P&Z CASE # _ SP2022-033 P&Z DATE July 12, 202	22 CC D	ATE Approved/Denied
ARCHITECTURAL REVIEW BOARD DATE	_HPAB DATE_	PARK BOARD DATE
Zoning Application  Specific Use Permit Zoning Change PD Concept Plan PD Development Plan		Copy of Ordinance (ORD#) Applications Receipt Location Map HOA Map
Site Plan Application  X Site Plan  Landscape Plan  Treescape Plan  Photometric Plan  Building Elevations  Material Samples  Color Rendering		PON Map FLU Map Newspaper Public Notice 500-foot Buffer Public Notice Project Review Staff Report Correspondence Copy-all Plans Required Copy-Mark-Ups
Platting Application  Master Plat Preliminary Plat Final Plat Replat Administrative/Minor Plat Vacation Plat Landscape Plan Treescape Plan		City Council Minutes – Laserfiche Minutes-Laserfiche Plat Filled Date
HPAB Application  Exhibit		
Miscellaneous Application  Variance/Exception Request	Zoning	Map Updated

PROJECT NAME: Site Plan for Dunkin' Donuts

CASE CAPTION: Discuss and consider a request by John Gardner of Kirkman Engineering for the approval of a Site Plan for a Restaurant with Less

DEPARTMENT	REVIEWER	DATE OF REVIEW	STATUS OF PROJECT	
PLANNING	Henry Lee	06/24/2022	Needs Review

A-7.1

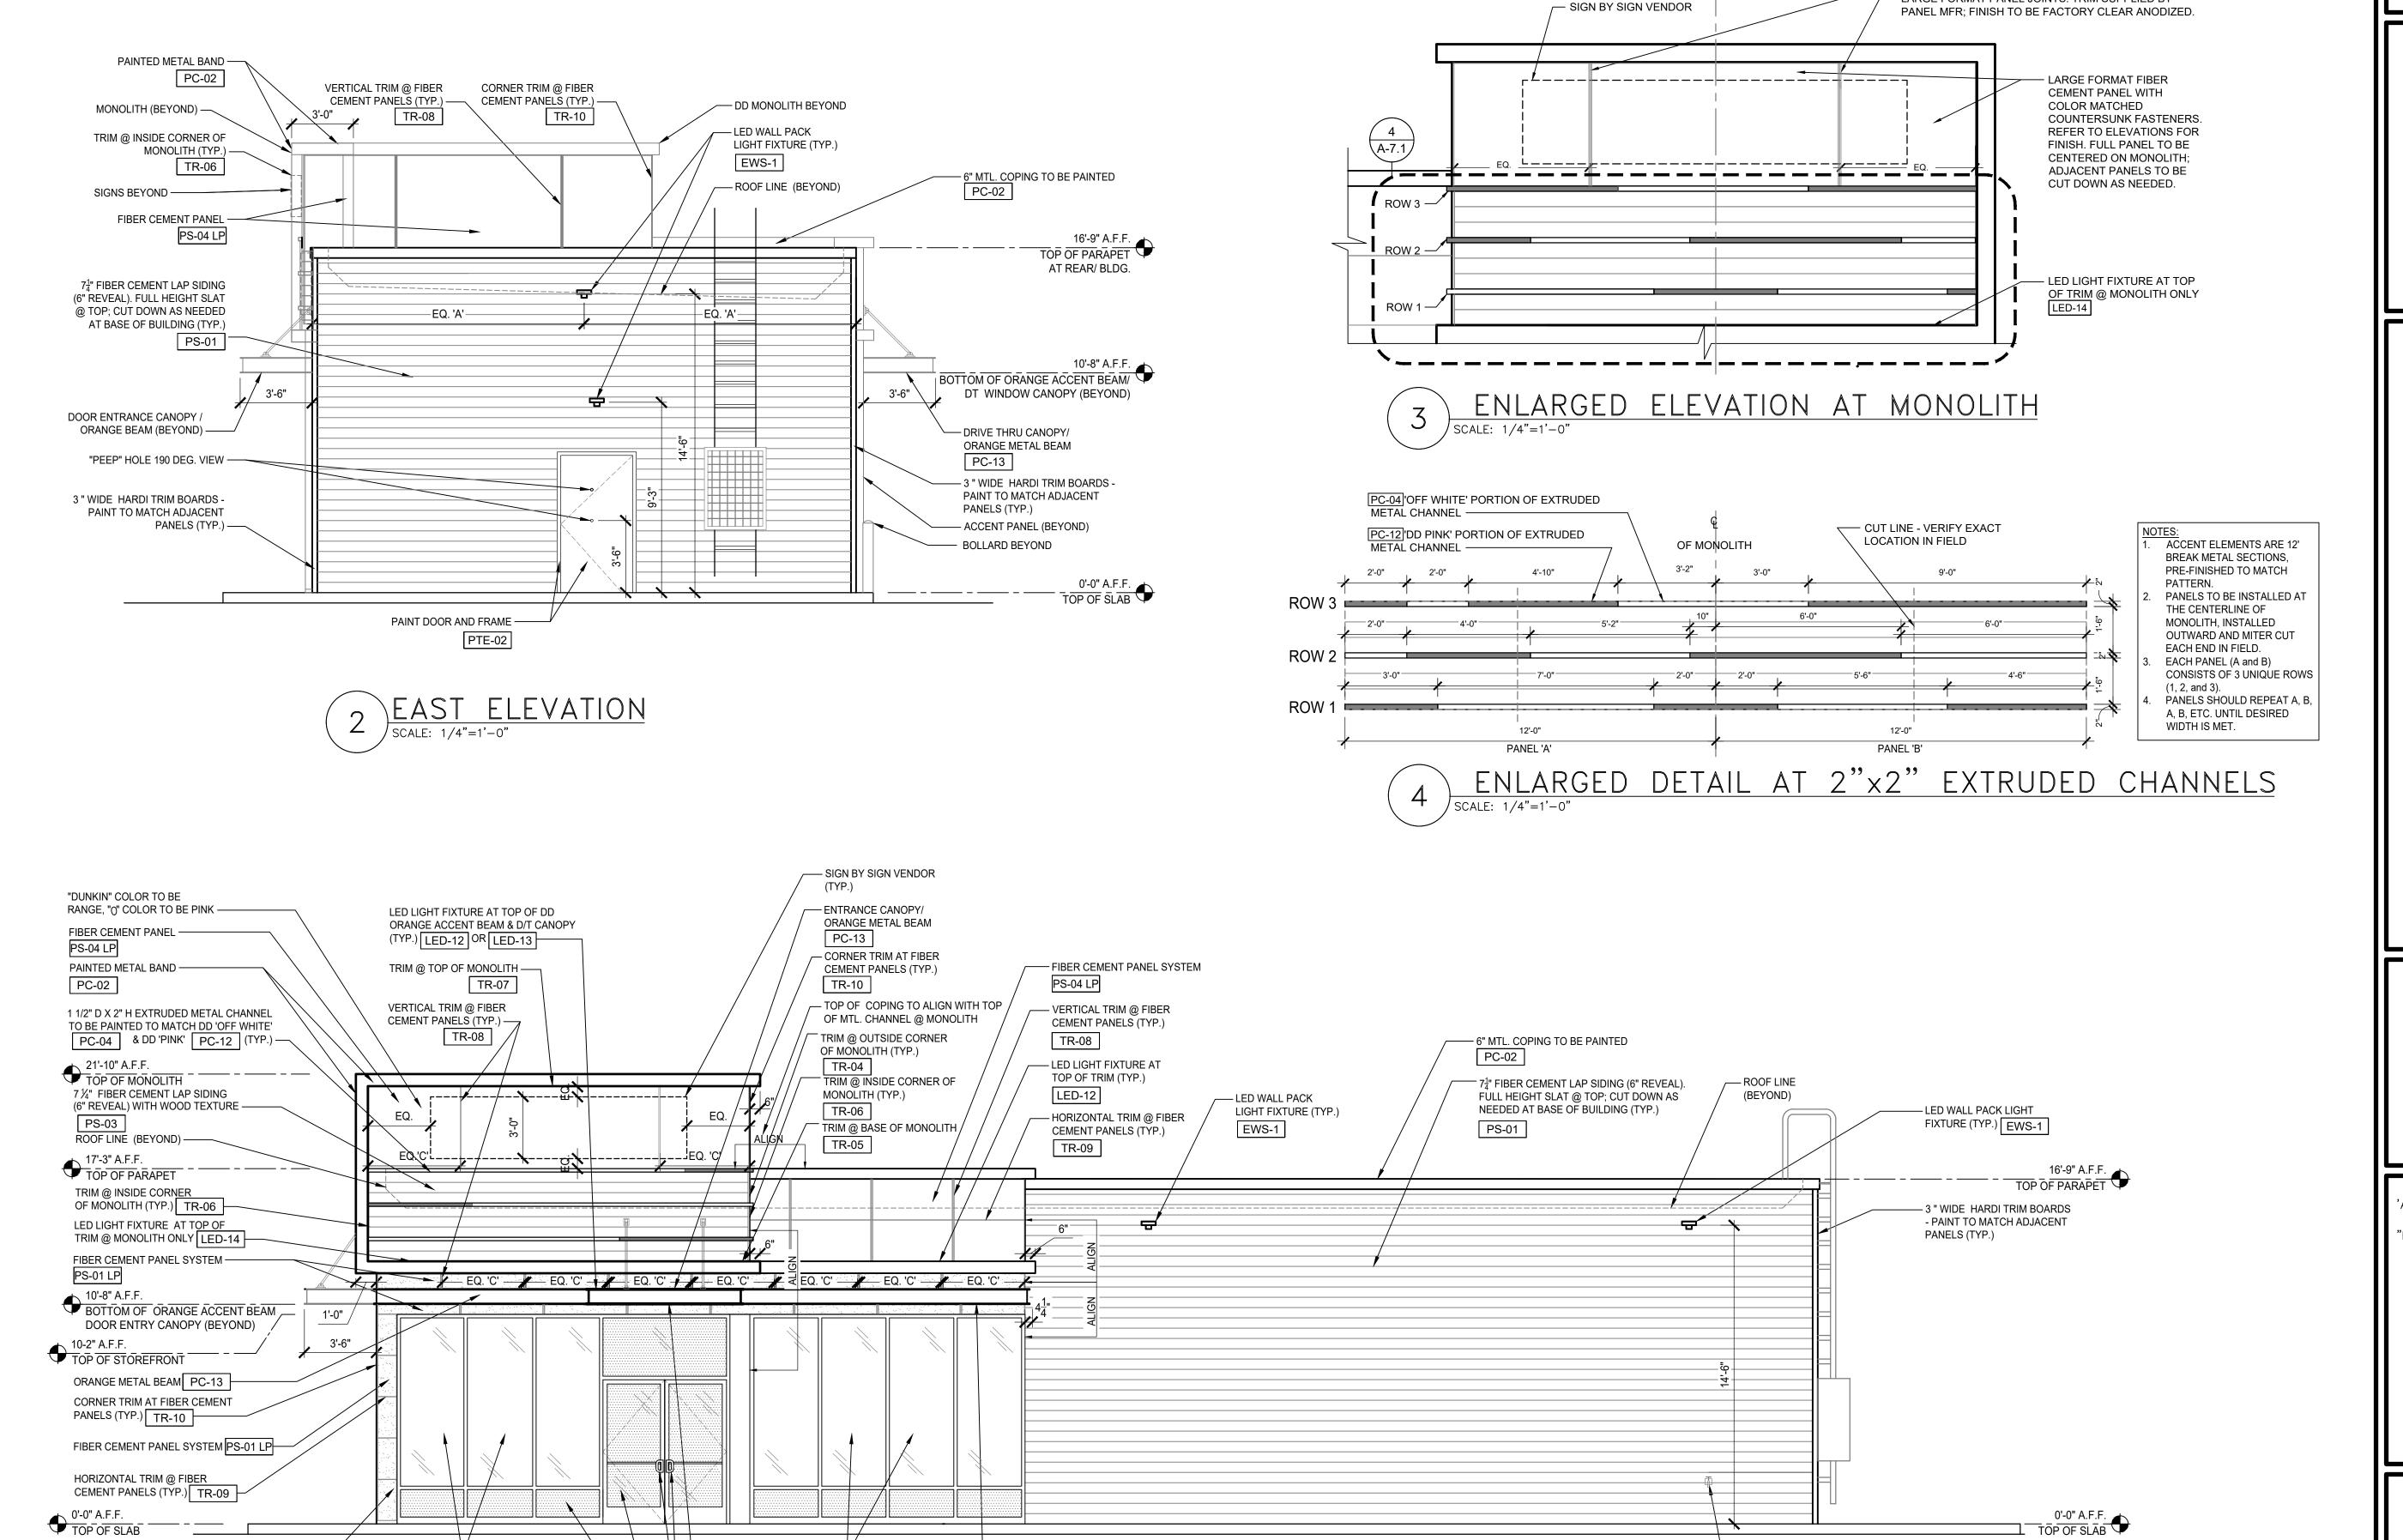
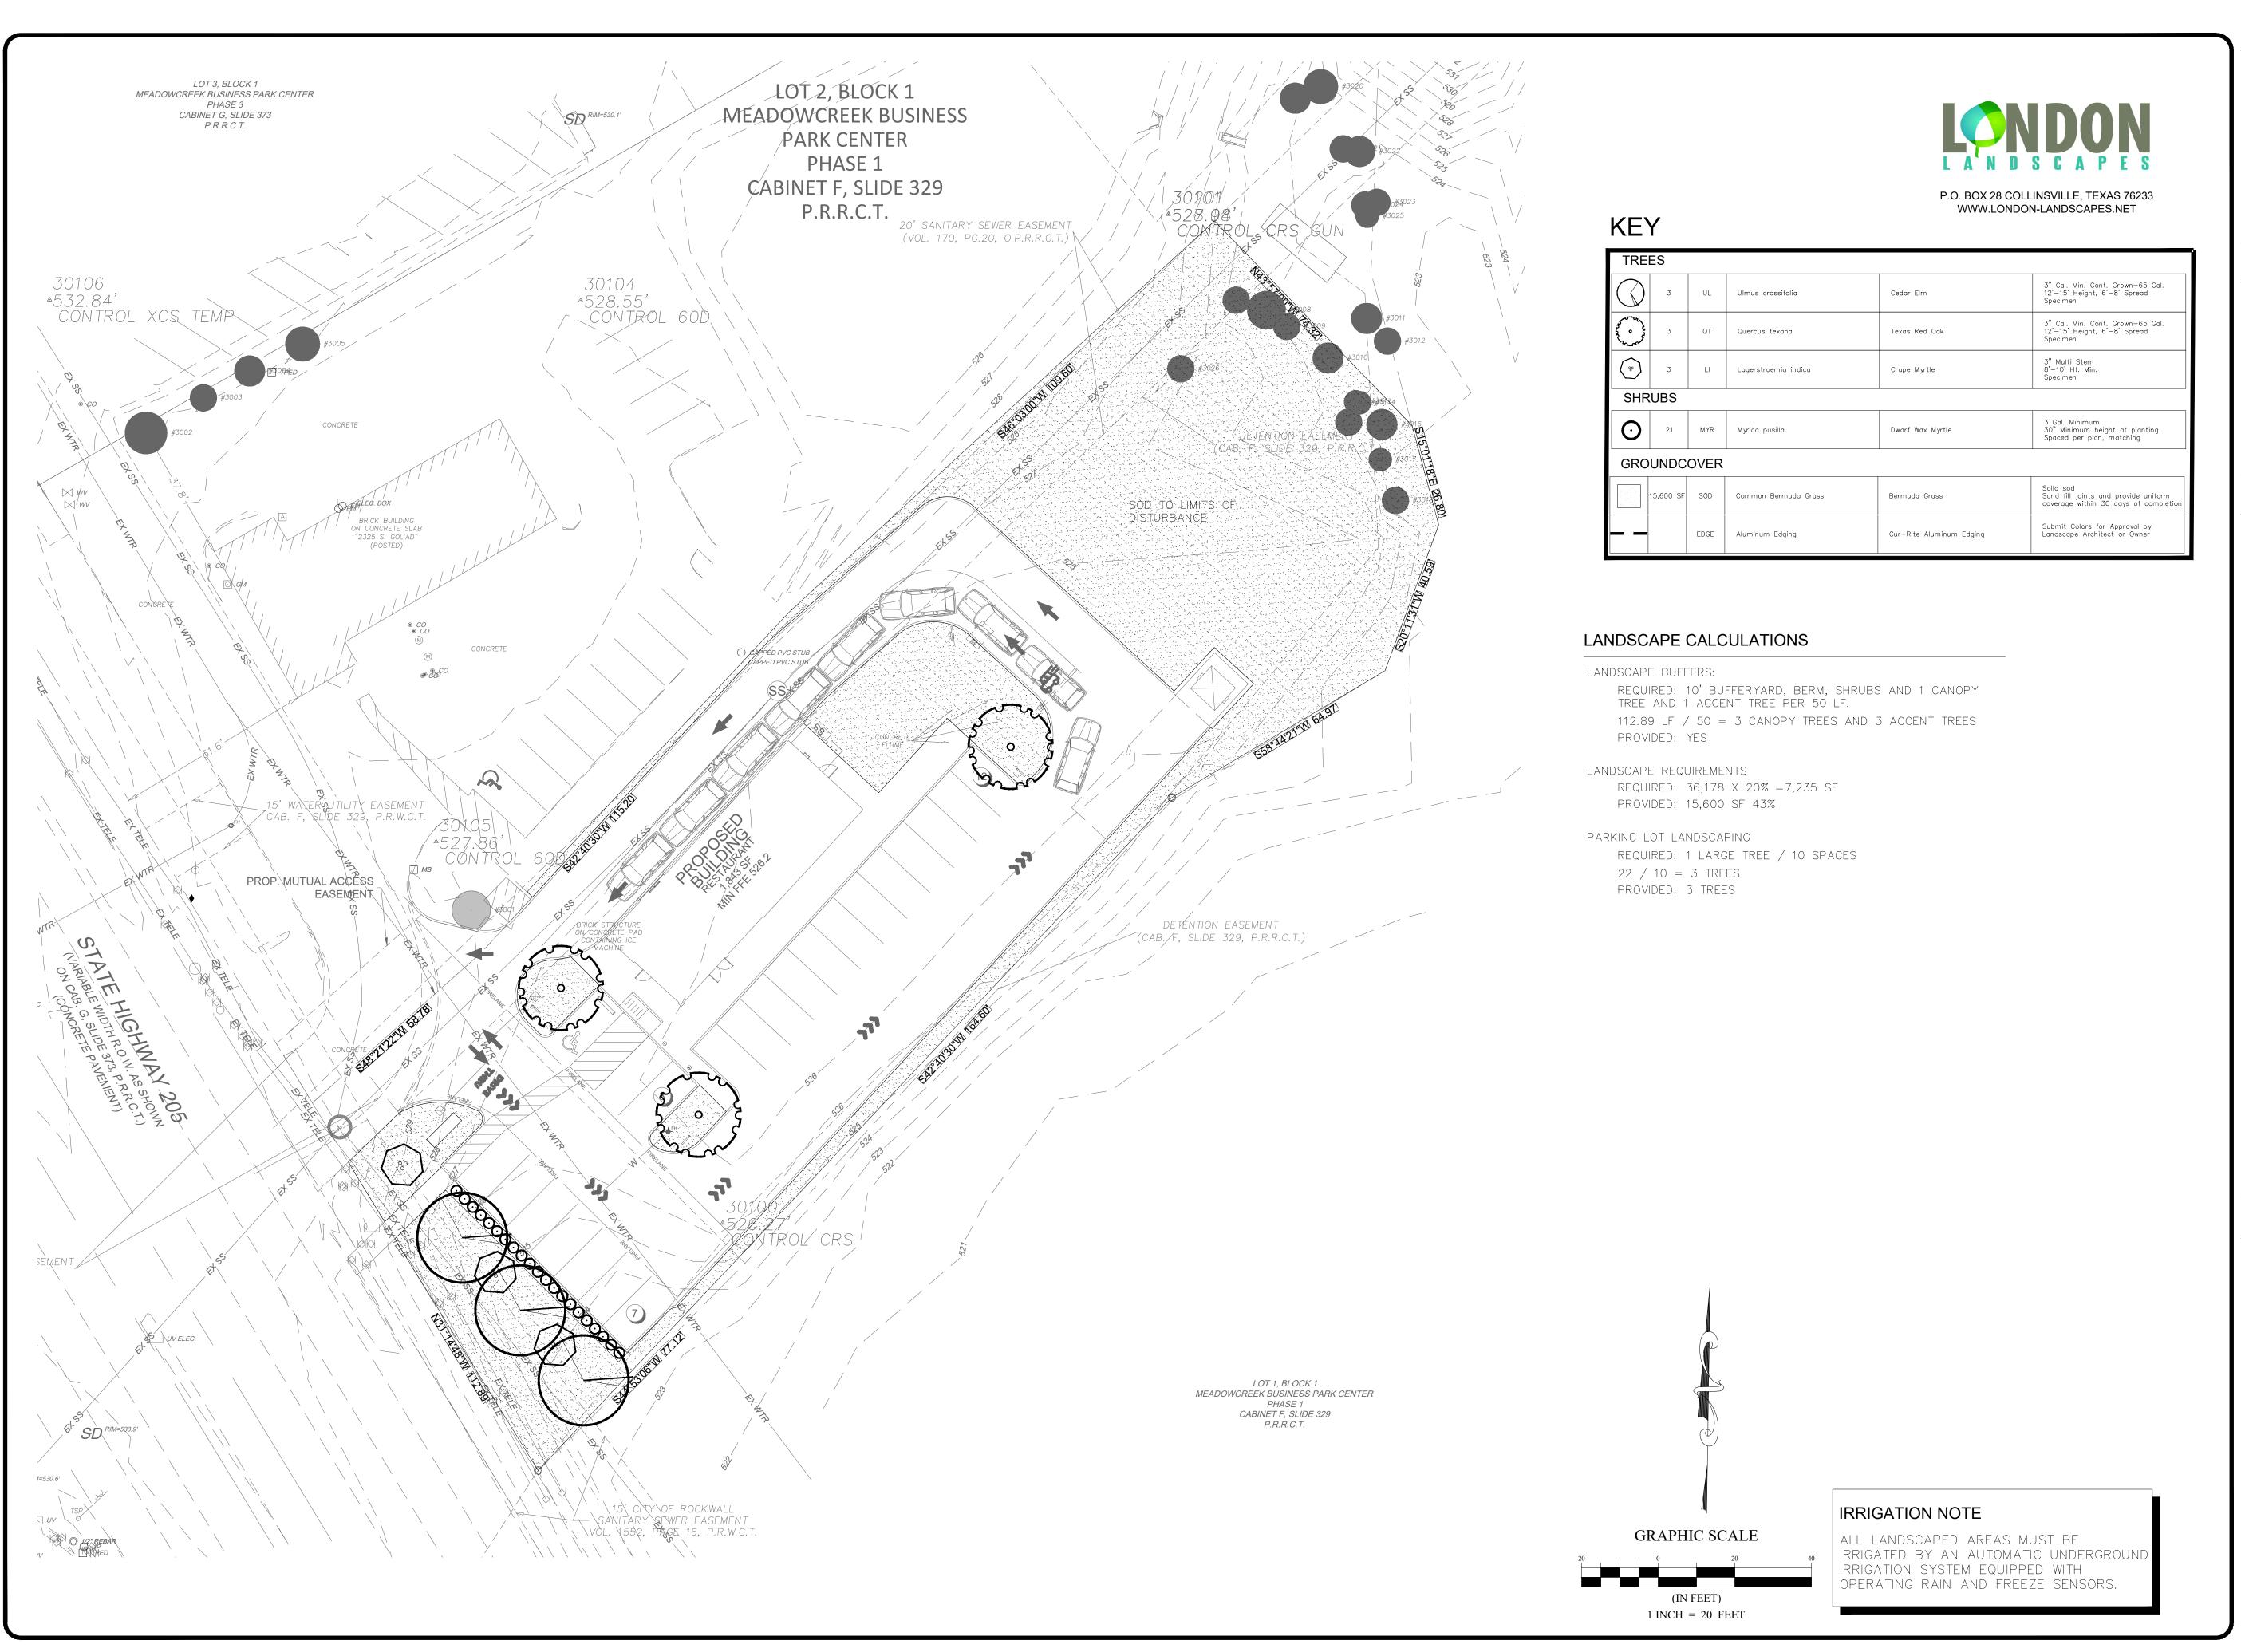
- 1. Please provide the material percentages on each façade of the proposed building. (Subsection 04.01, of Article 05)
- 2. 20% natural or quarried stone is required on each façade of the proposed building. (Subsection 06.02. C, of Article 05)

- 5. Please provide more information on the proposed materials. (Subsection 04.01, of Article 05)
- 6. Include a note that the parapet will be finished on both sides with the same material as the external facing façade. Also, indicate the parapet height. (Subsection 04.01, of Article 05)
